Access Compliance Report

Public Rights-of-Way

(Curb Ramps)

Intersection ID: 11511	Main Street: E_18TH_ST	Cross Street: N_DAVIDSON_ST	Location: N
ADA ID: AABA60DCD6EC	Ramp Type: PerpDiag	Initial Pass/Fail: Fail	Overall Compliance: No
Severity Score: 13.75			
Codes/Mitigation Info/Possible Solution		Field Measurements/Component Compliance

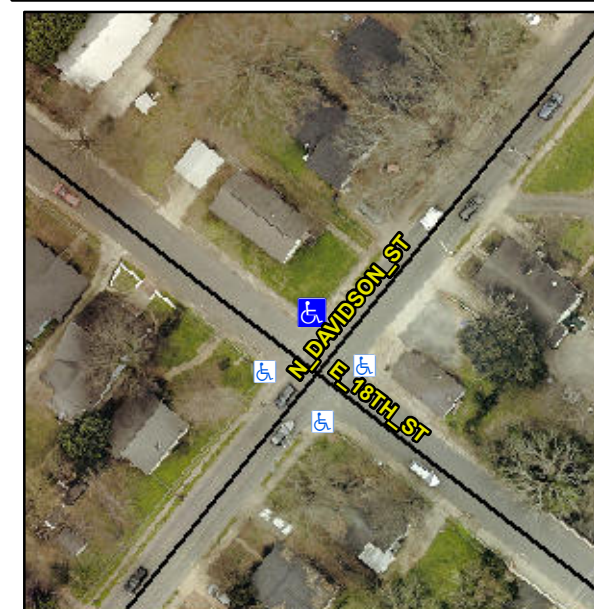
Not Found, R304.2.2, R304.5.3

Compliance	Description	Data	Compliance	Description	Data
N/A	Ramp Length (in)	57.0	No	Ramp Slope (%)	11.0
Yes	Ramp Width (in)	50.0	No	Ramp XSlope (%)	2.2
N/A	Flare Type LT	N/A	N/A	Flare Type RT	N/A
N/A	Flare Slope LT (%)	N/A	N/A	Flare Slope RT (%)	N/A
N/A	Flare Traversable LT?	N/A	N/A	Flare Traversable RT?	N/A
N/A	Landing Length (in)	N/A	N/A	DWS Provided?	N/A
N/A	Landing Width (in)	N/A	N/A	DWS Contrast?	N/A
N/A	Landing Slope (%)	N/A	N/A	DWS Length (in)	N/A
N/A	Landing X Slope (%)	N/A	N/A	DWS Full Width?	N/A
N/A	Landing Curb? (Y/N)	N/A	N/A	DWS Offset (in)	N/A
N/A	Shared Landing?	N/A			
N/A	Gutter Ponding?	N/A	N/A	Gutter Slope (%)	N/A
N/A	Gutter Lip Ht (in)	N/A	N/A	Gutter X Slope (%)	N/A
N/A	Painted X Walk1?	No	N/A	Painted X Walk2?	No
	X Walk 1 Direction	To SW		X Walk 2 Direction	To SE
N/A	X Walk 1 Width (in)	N/A	N/A	X Walk 2 Width (in)	N/A
	X Walk 1 Slope (%)	3.1		X Walk 2 Slope (%)	2.2
	X Walk 1 X Slope (%)	0.6		X Walk 2 X Slope (%)	3.4

Remove & Replace Curb Ramp With Two New Directional Ramps or Equivalent.
